**Template for Requesting Speaking Rights at the Planning Committee**

<b>Planning Reference</b>	LA01/2025/0631/F
<b>Name</b>	Alana Jackman
<b>Contact Details</b>	Tel: _____ Email: _____
<b>Support or Objection – please tick relevant box</b>	Support <input type="checkbox"/> Objection <input checked="" type="checkbox"/>
<p><b>Written representation summarising key points to be addressed and supplementary information in support of your case (minimum font size 10 and maximum length two sides of A4 page).</b></p> <p>Please see attached word document with key objections.</p>

Latest survey of 05.08.2025

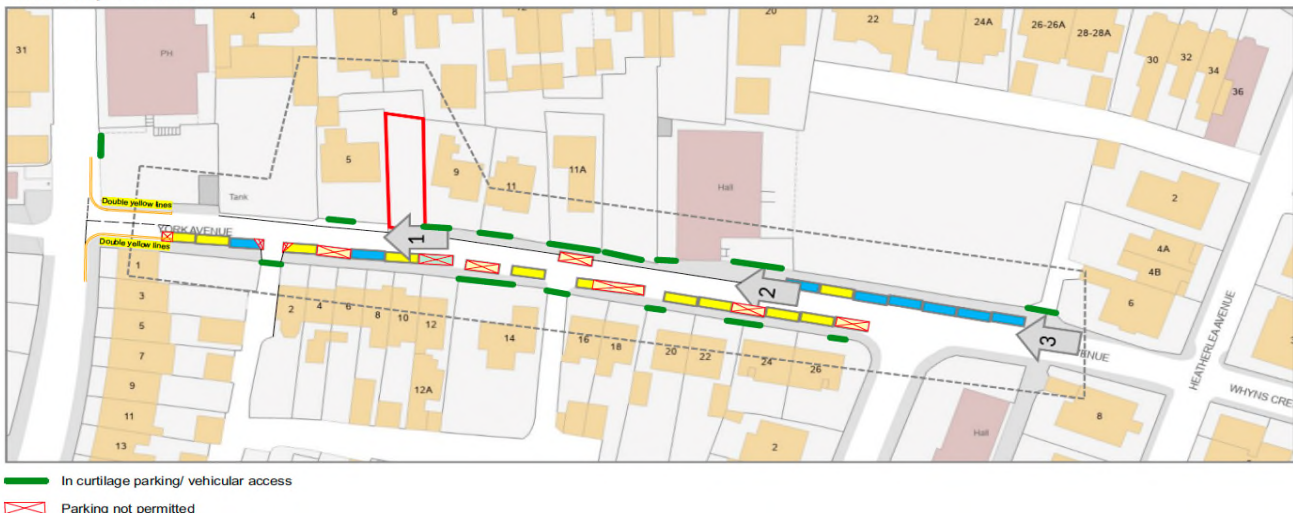
2. **There is insufficient street parking for all current residents**. See diagram below with amendments requested by DFI in their response (24<sup>th</sup> July 2025) to the applicant's private street survey. The applicants resubmitted their private parking survey on 8-9-2025 which still showed parking opposite existing vehicular accesses which is not acceptable (DFI letter 24-07-2025)

- a) The parking survey re-submitted on 8<sup>th</sup> Sep suggests there are a total of 26 available spaces in the street. However, 10 of these are in spaces that are not permitted. See our annotated diagram below where 10 of the spaces have red hatches through as they are not acceptable.

This leaves a **maximum of 16 places** in the whole street, for 17 dwellings plus a Scout Hall

1. Too near junction with Central Ave (car was parked 1/3 of the yellow lines)
2. 1 to left of the lane does not have 45 degree allowance for exit at lane beside 2 York Ave
3. 1 to right of the lane does not have 45 degree allowance for exit at lane beside 2 York Ave
4. 1 is opposite in-curtilage parking on No. 5
5. 1 is opposite in-curtilage parking on No. 9
6. 1 is opposite in-curtilage parking on No. 11
7. 1 is parked outside No.11a. opposite no.14 – which also has a solid white line outside the property
8. 1.5 outside 16 & 18 opposite vehicle access
9. 1 between 22 & 24 opposite vehicle access
10. Outside no. 26, too close to corner of York Park

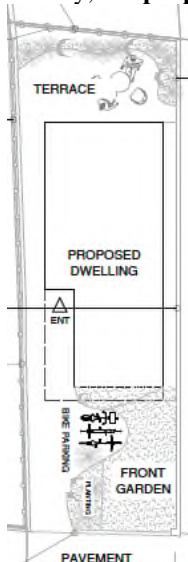
The house width is less than half of the adjacent properties at No.5 and No.9

House 10.6M wide  
Plot 12.5M wide

House 4.4M wide  
Plot 5.8M wide

House 9.5M wide (set back)  
Plot 12M wide

The proposed plans show that the building would be positioned just 600mm from the boundary of No.9 and 800mm from the boundary of No. 5. This is extremely constrained and we would question the feasibility, practicality and buildability of the proposal.
